Notice of Intent

Type of Action: Plug and Abandonment

PLUG AND ABANDONMENT CONDITIONS OF APPROVAL

OPERATOR'S NAME:	Apache Corporation
LEASE NO.:	NMLC031844
WELL NAME & NO.:	Junction Fed 1
US Well Number:	3001533533
LOCATION:	Section 19, T.17 S., R.31 E., NMPM
COUNTY:	Eddy County, New Mexico
Sundry ID:	2675157
Karst:	<input checked="" type="checkbox"/> Low <input type="checkbox"/> Medium <input type="checkbox"/> High <input type="checkbox"/> Critical
Potash:	<input type="checkbox"/> Secretary <input type="checkbox"/> R111P
Special Area:	<input checked="" type="checkbox"/> Prairie Chicken <input type="checkbox"/> Capitan Reef

LEASE NAME	JUNCTION FEDERAL
WELL #	#001
API #	30-015-33533
COUNTY	EDDY, NM

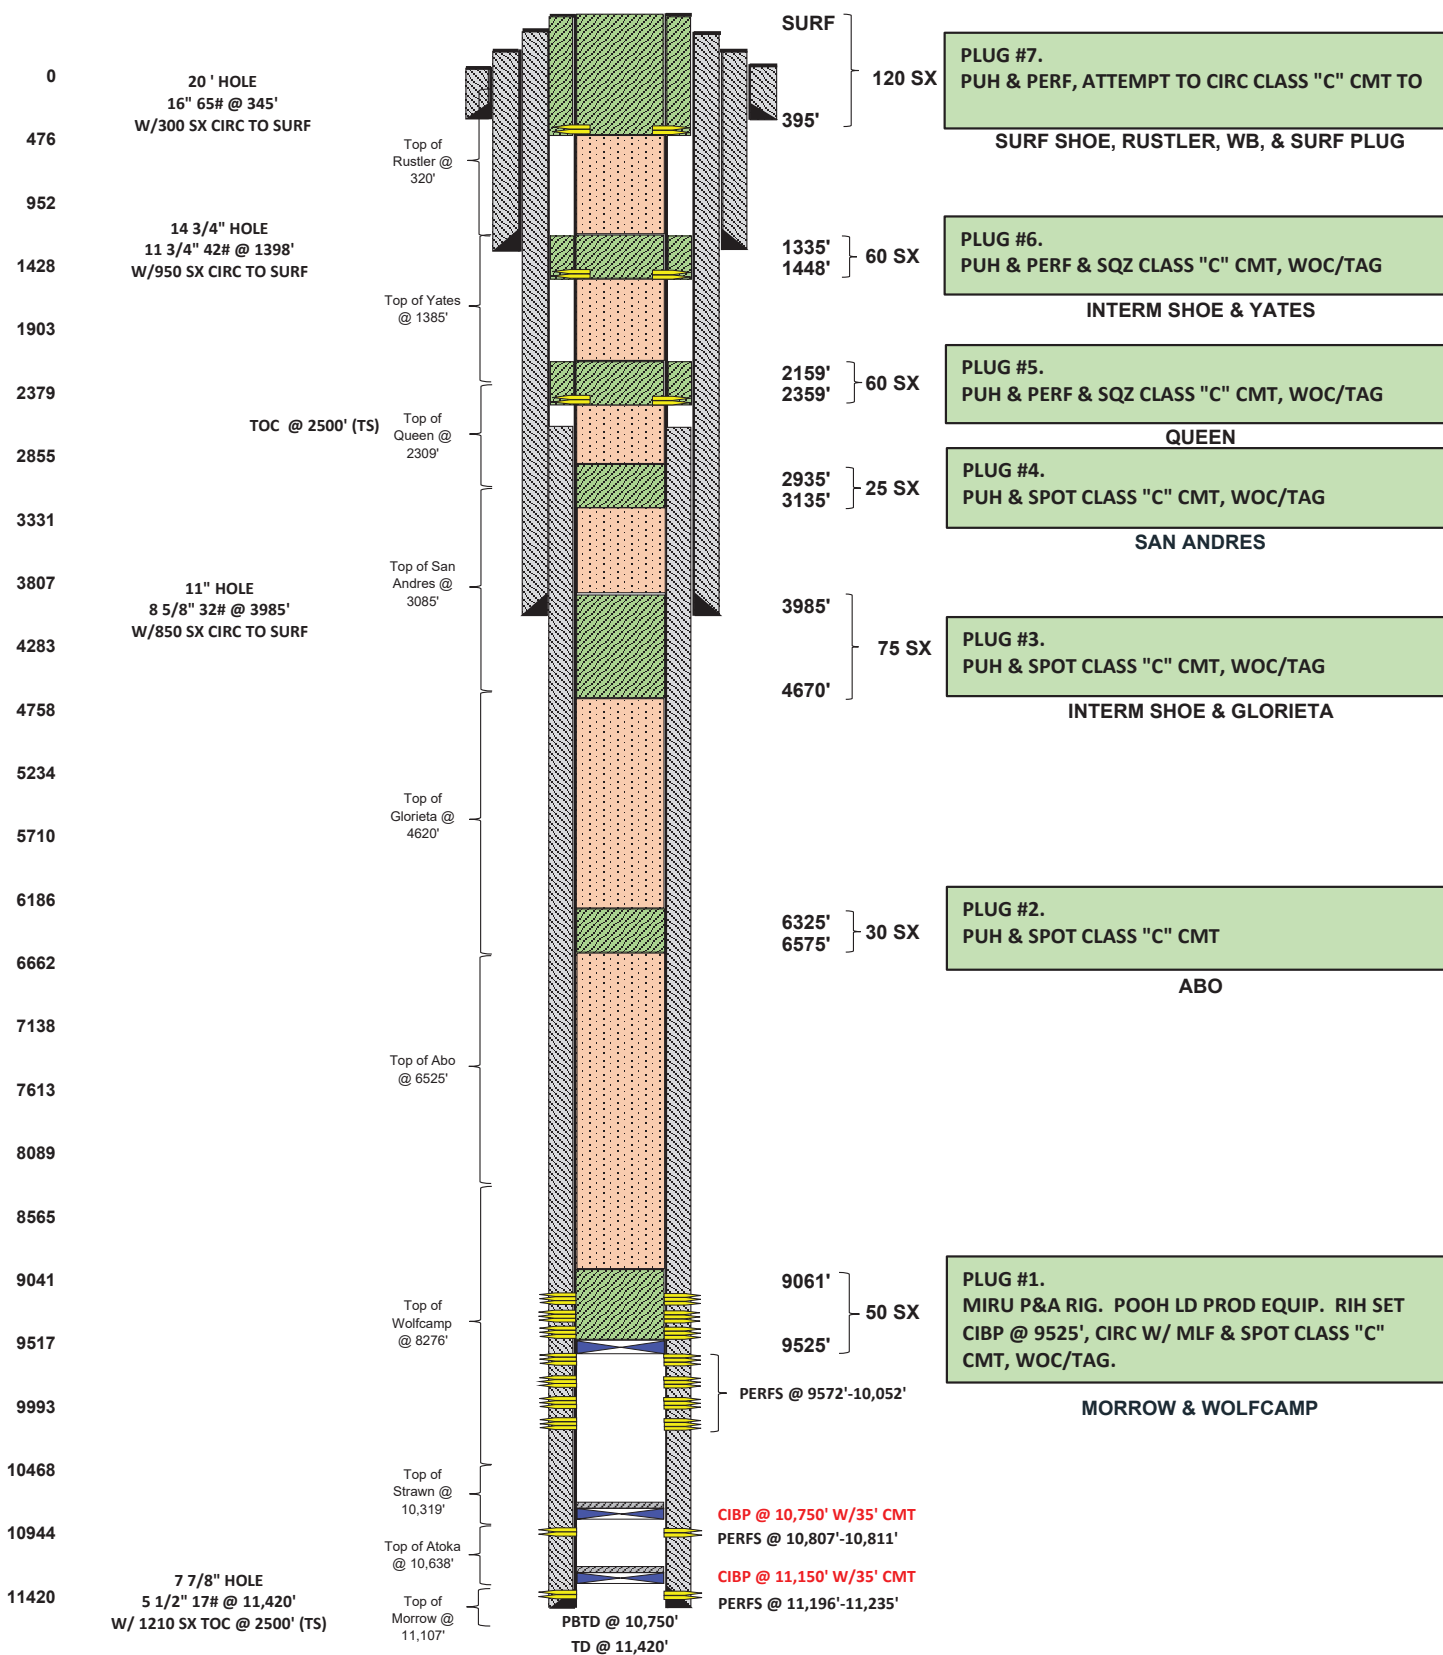
1. MIRU P&A Rig. POOH LD prod equip. Tag CIBP at 10715'. RIH set CIBP @ 9525'-9111', CIRC W/ MLF & Spot Class "C" CMT, WOC/Tag. (9525'-9061') 50 sx Leak Test CIBP.

Spot from 8326' to 8143'. 25 sx (Wolfcamp)

2. PUH & Spot Class "C" CMT. (~~6575'-6325'~~6826'-6658') 30 sx

3. PUH & Spot Class "C" CMT. (~~4670'-3985'~~4591'-3985') 75 sx WOC & Tag

6. PUH & Perf & Sqz Class "C" CMT. (~~1448'-1335'~~1456'-1207') 60 sx WOC & Tag (In/Out)

7. PUH & Perf, Attempt to circ Class "C" CMT to surface. (~~546395'~~-surf) 128420 sx (In/Out)

Plug Type	Top	Bottom	Length	Tag	Sacks	Notes
Surface Plug	0.00	546.00	546.00	Tag/Verify		
Shoe Plug	291.55	395.00	103.45	Tag/Verify		
Top of Salt @ 496	441.04	546.00	104.96	Tag/Verify	128.00	Perf and Squeeze from 546' to surface. (In/Out) Verify at Surface.
Base of Salt @ 1270	1207.30	1320.00	112.70	Tag/Verify		
Shoe Plug	1334.02	1448.00	113.98	Tag/Verify		
Yates @ 1406	1341.94	1456.00	114.06	If solid base no need to Tag (CIBP present and/or Mechanical Integrity Test), If Perf & Sqz then Tag, Leak Test all CIBP if no Open Perforations	60.00	Perf and Squeeze from 1456' to 1207'. WOC and Tag. (In/Out)
Shoe Plug	3895.15	4035.00	139.85	Tag/Verify

If solid base no need to Tag (CIBP present and/or Mechanical Integrity Test), If Perf & Sqz then Tag, Leak Test all CIBP if no Open Perforations		
Glorieta @ 4541	4445.59	4591.00	145.41		75.00	Spot from 4591' to 3985'. WOC and Tag.
				If solid base no need to Tag (CIBP present and/or Mechanical Integrity Test), If Perf & Sqz then Tag, Leak Test all CIBP if no Open Perforations		
ABO in Plateform Shelf @ 6776	6658.24	6826.00	167.76		30.00	Spot from 6826' to 6658'.
